SHOP DRAWINGS
Comfort Station
Truss

PROJECT: Fort Harrison State Park
Comfort Station

F-4

Comfort Station Truss

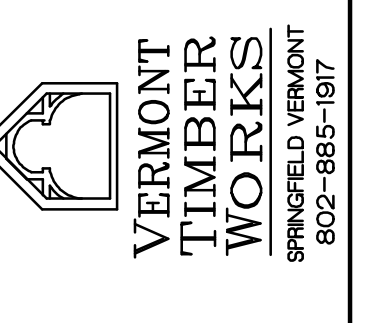
Note: The Structural Drawings and Architectural Drawings do not match. Architect must verify dimensions to insure that conventional trusses and timber trusses align.

Note: Wood species has been changed to solid Fir #1 & Better, and joinery has been changed to Traditional to allow for flush cedar cladding. Cladding over steel joinery is not recommended. Solid cedar beams can be provided for an add of \$1850.00.
